PRODUCT / PROCESS CHANGE NOTIFICATION

PCN-000764

For business continuity purposes, Semtech will start using qualified second-sources for assembly of the above-mentioned parts.

Qualification of Greatek Taiwan for SX1301/ SX1308 products

SEMTECH Package Outline on SX1301IMLTRT/ SX1308IMLTRT Carsem (Old) and Greatek (New)

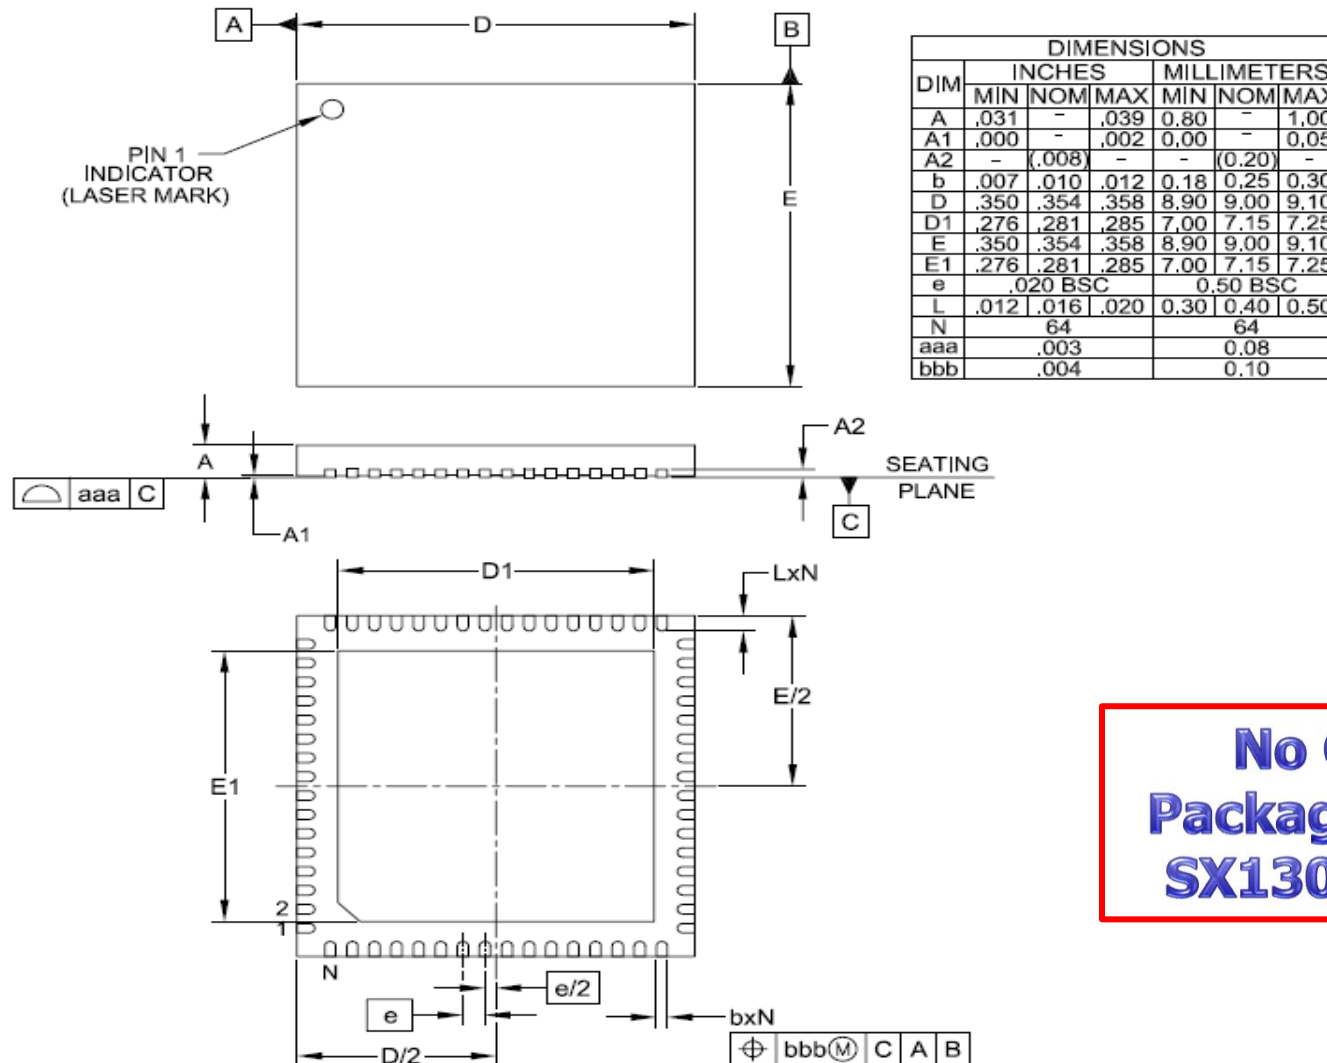
**No Change in
Package Outline for
SX1301 / SX1308.**

Assembly Process Flow Comparison for Carsem (Old) vs. Greatek (New)

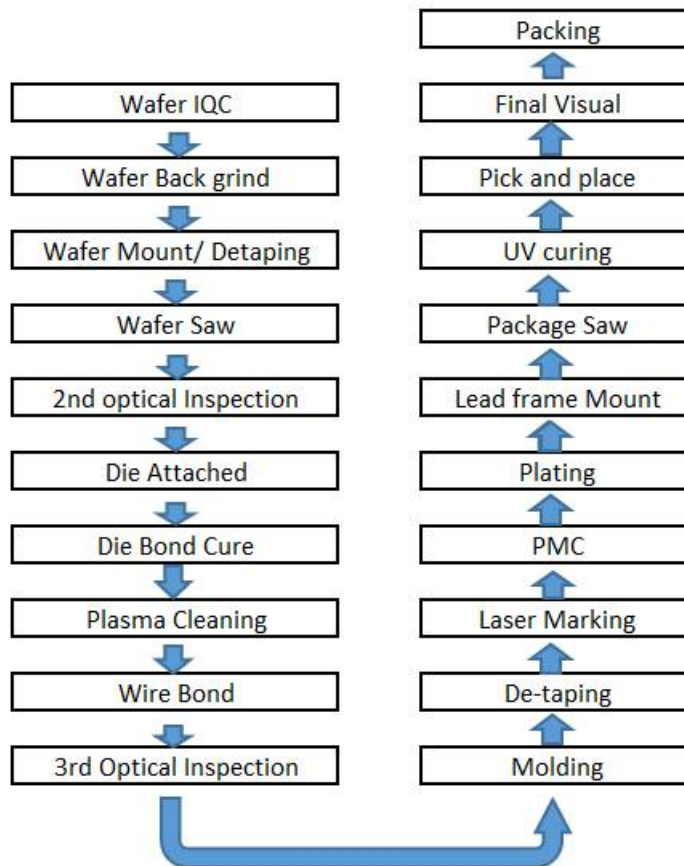
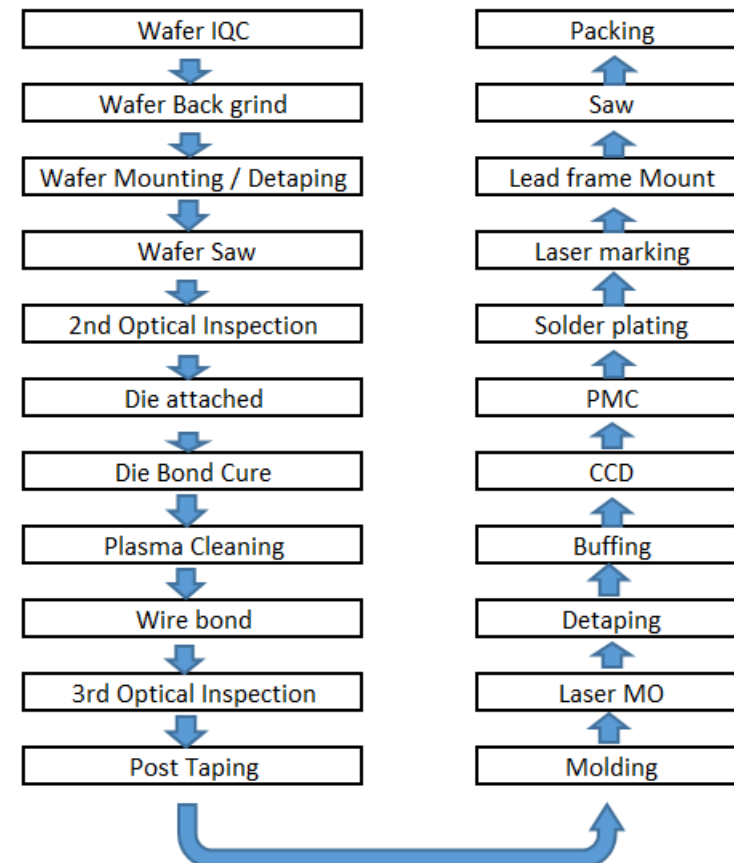
- No major Change in manufacturing Flow

Bonding Layout (Carsem vs Greatek)

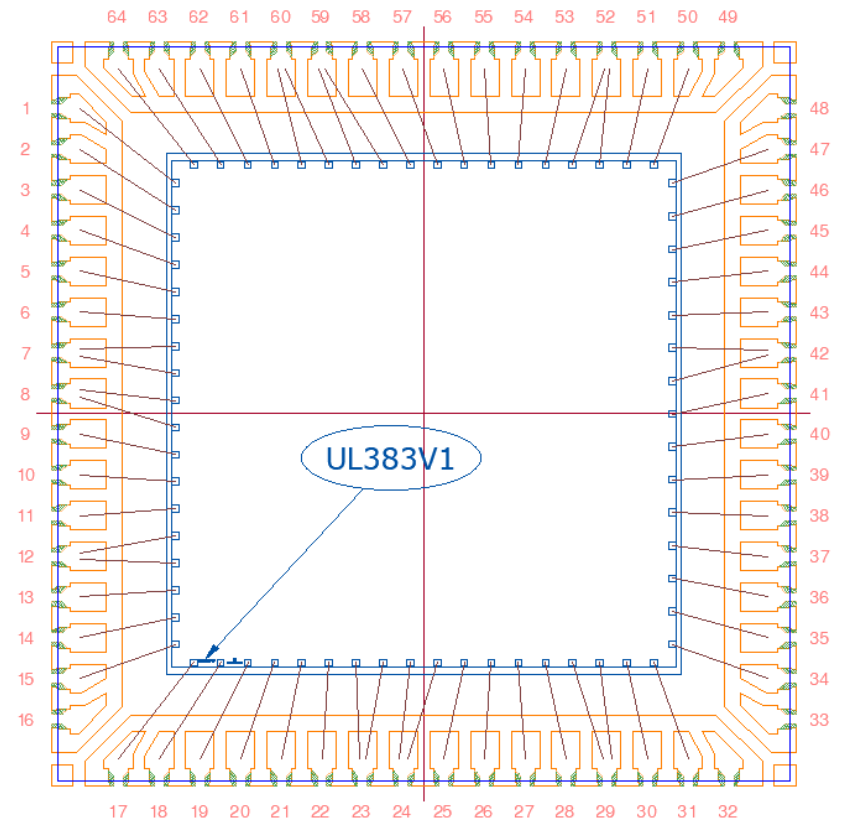
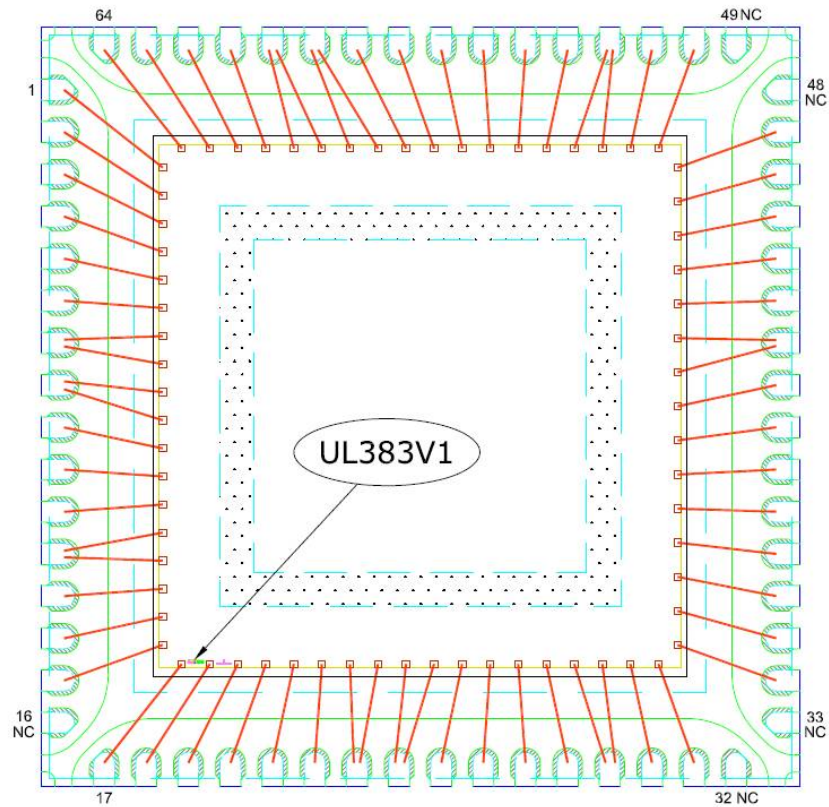
No Change in Bonding Layout.
